RE: Drainage plan Southerly portion of the Shores development

RE: Morris Manor (formerly called The Shores) and the existing The Shores planned residential development.

RE: Drainage Report for "The Shores" Addition

·Subject: Drainage Report for "The Shores" Subdivision

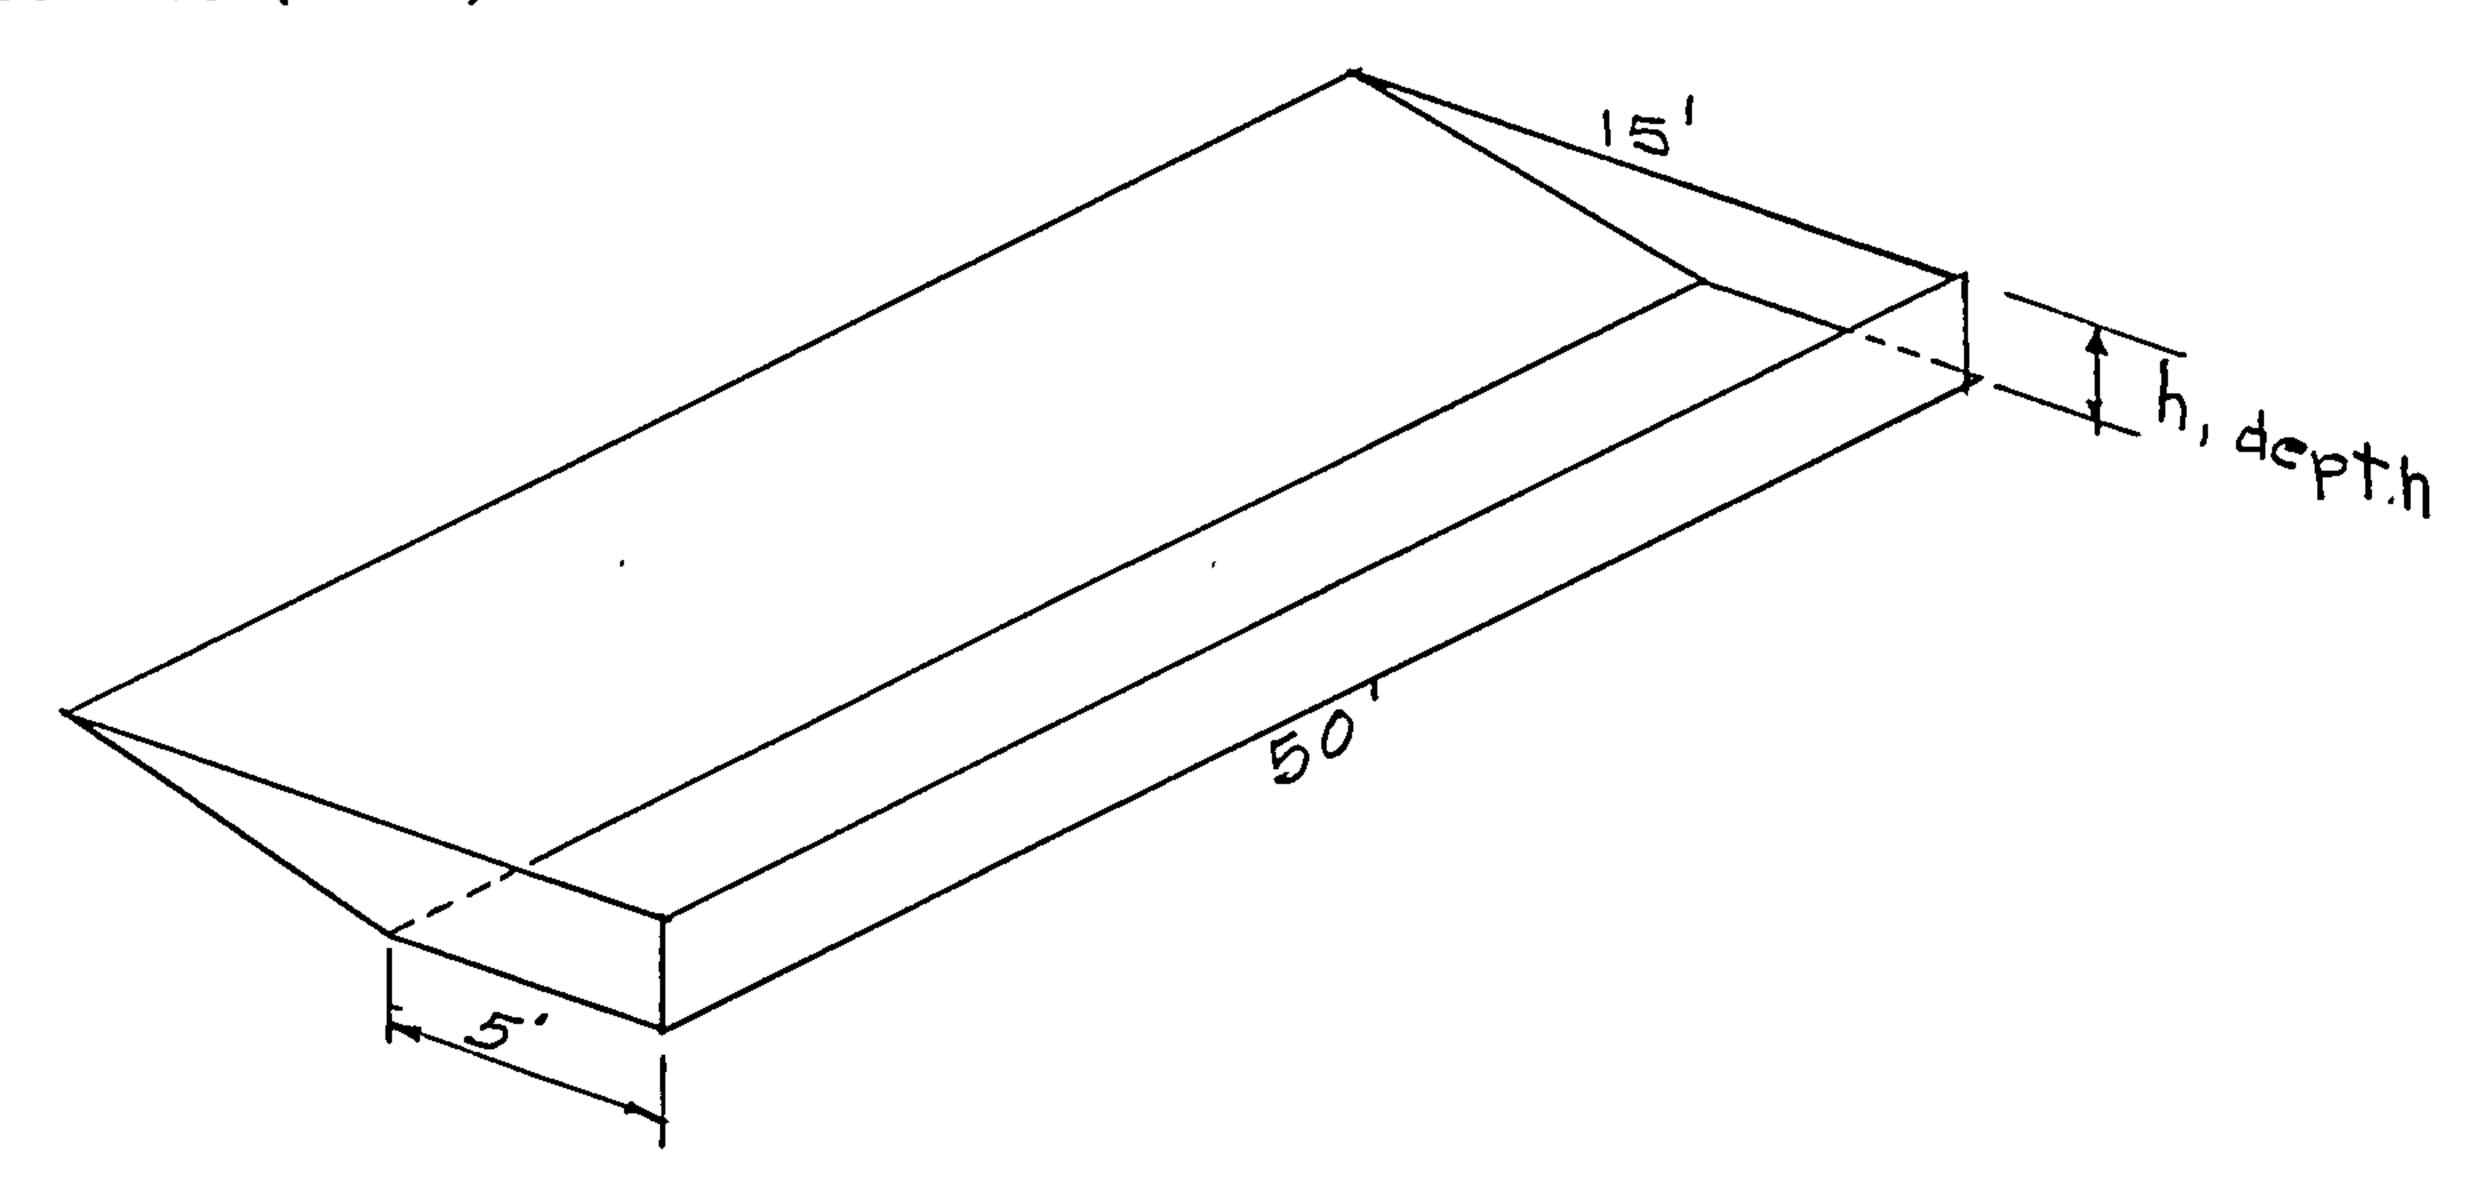
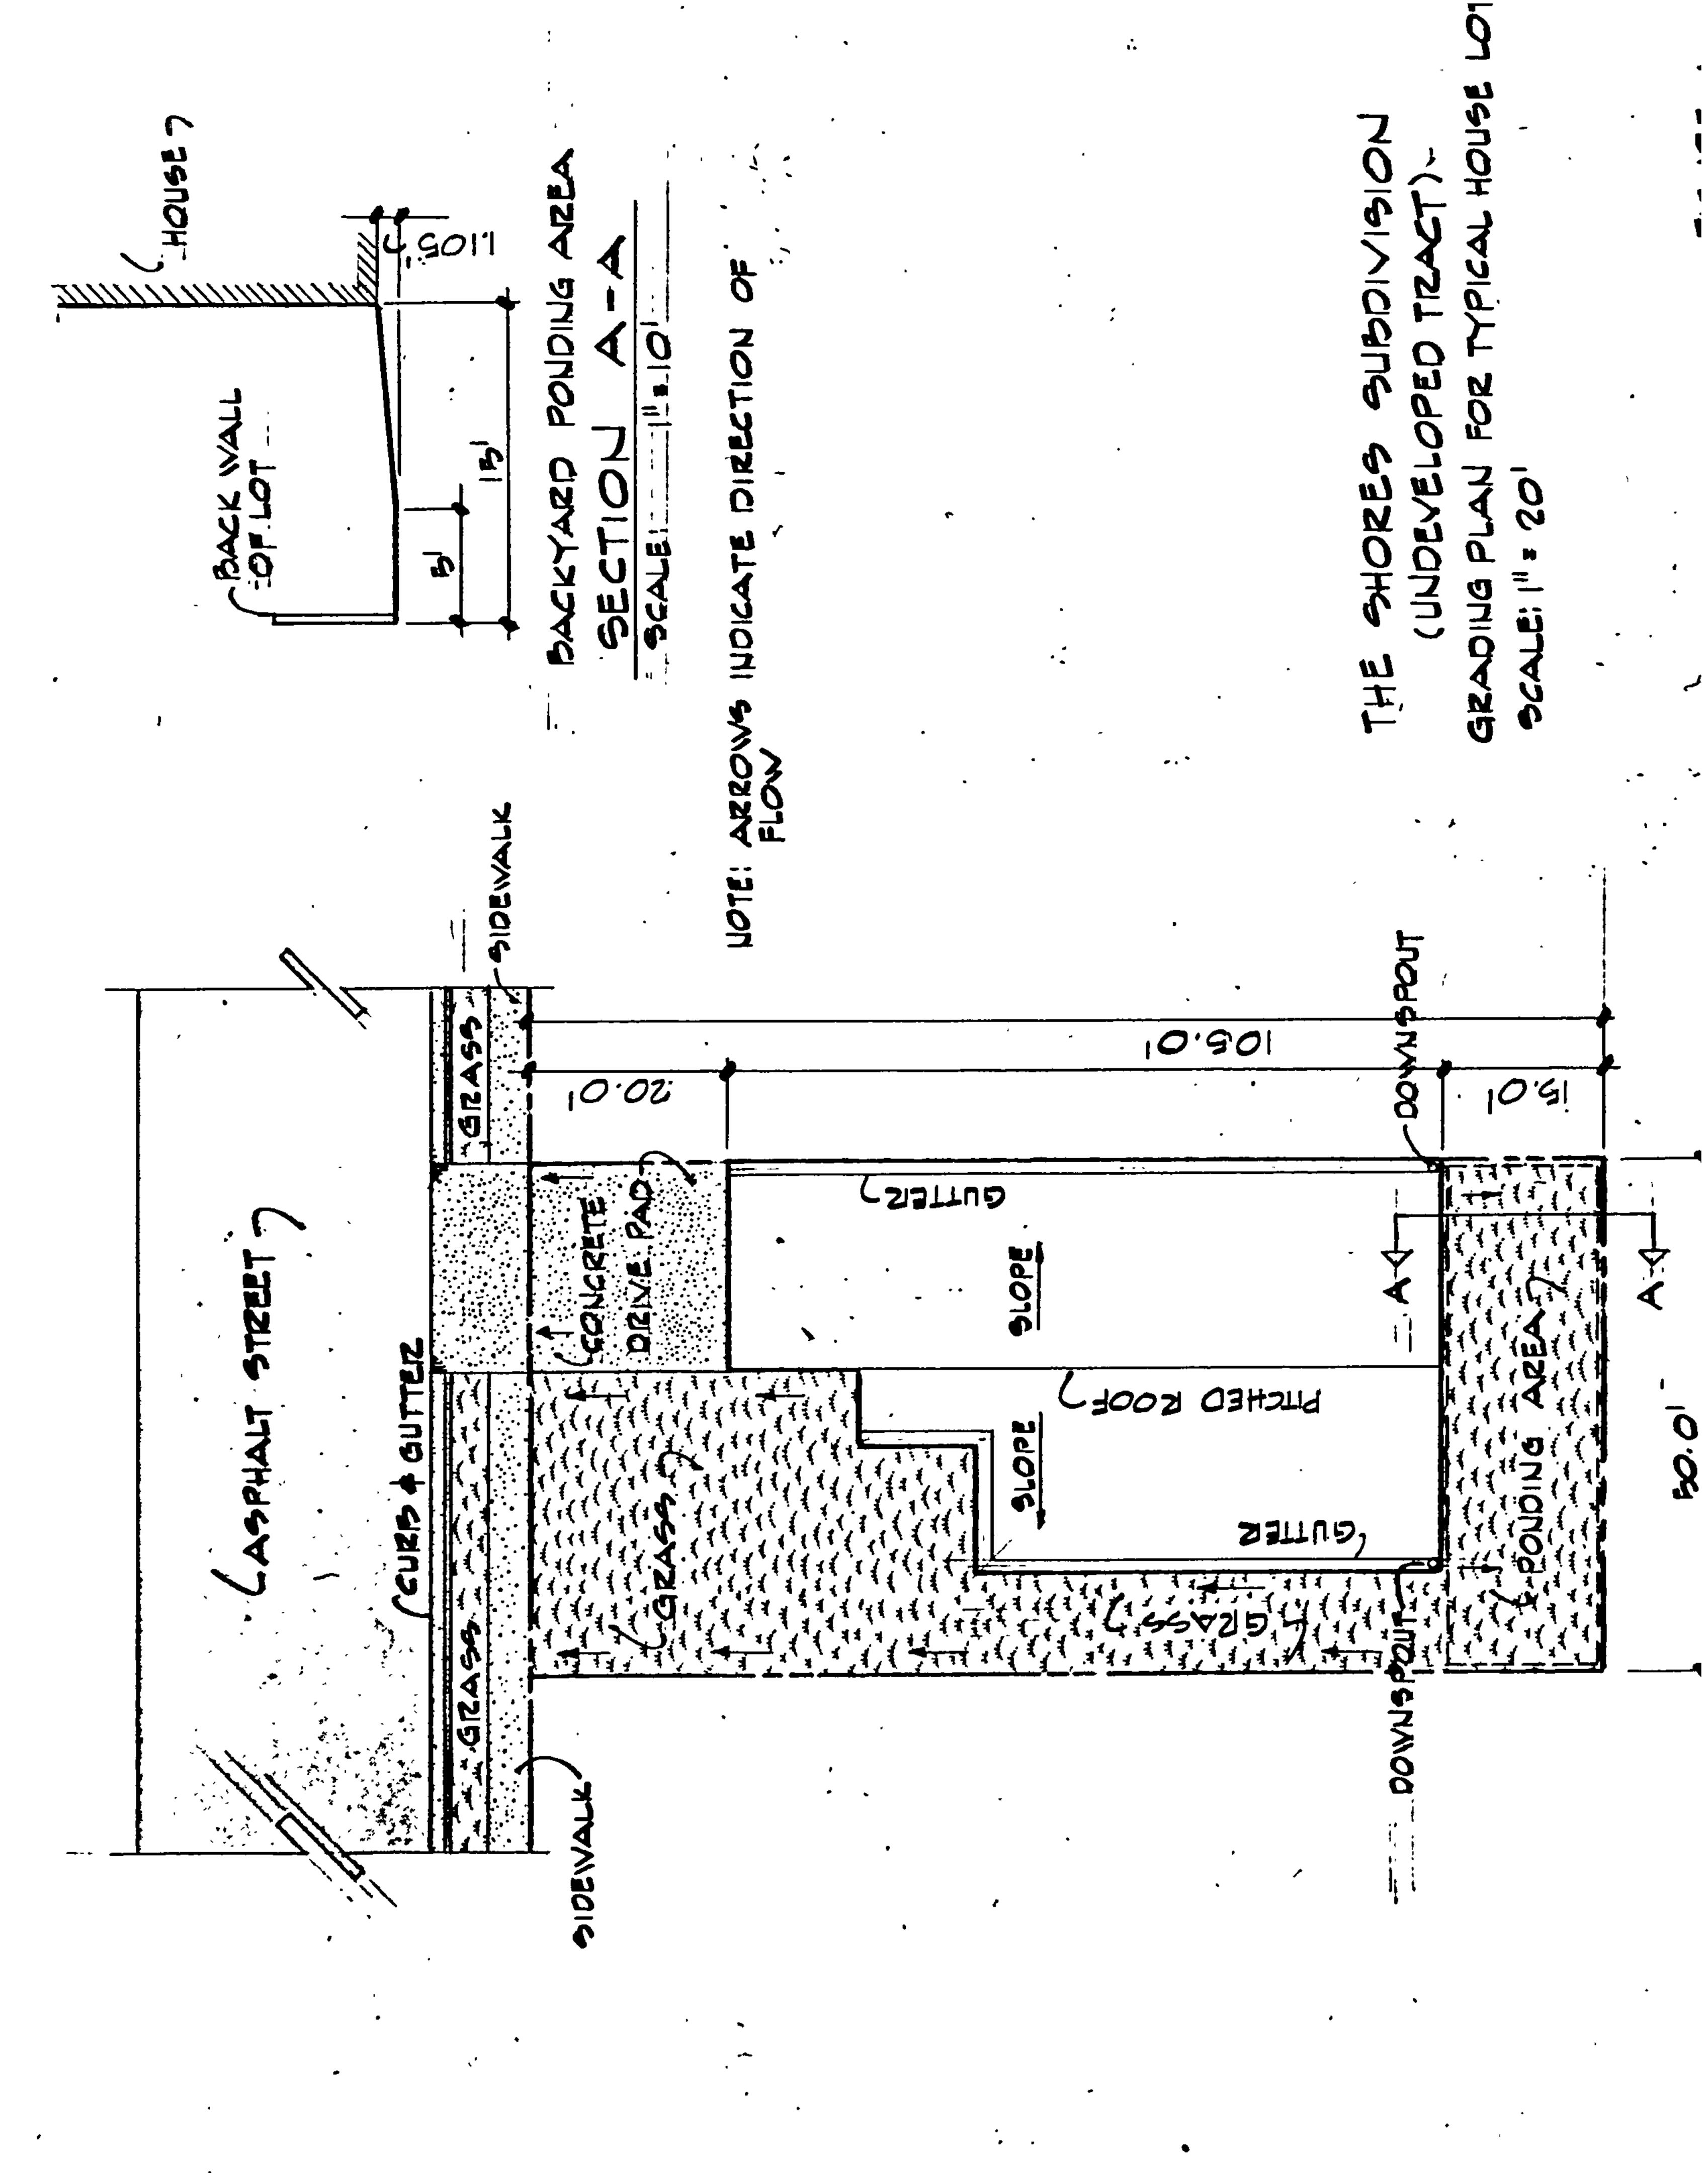
Regarding the question of backyard ponding, an error is noted on page A-3. The surface of the ponding areas is indicated in 72000 sq. ft. while all the previous computations reported a surface area of 32000 sq. ft. Correspondingly, the depth of ponding should be 15.2 in. instead of the indicated 11.0 in.

Due to a lack of coordination on our part some revisions in our drainage report calculations failed to be included in the final draft of our report. Thus, we are enclosing corrected copies of pages 4, A-2, A-3, and FIGURE 1. We have also incorporated in these revised calculations, the following revised values in order to comply with your recently promulgated STANDARD REQUIREMENTS FOR DRAINAGE PLANS:

As is shown on revised page A-3 and FIGURE 1, the recomputed depth of ponding is 13.26 inches or 1.105 feet.

All downspouts from roofs must be located so as to lead run-off to backyard lawn ponding areas. See FIGURE 1 for design details.

Recommended depth, h = 13.26 inches
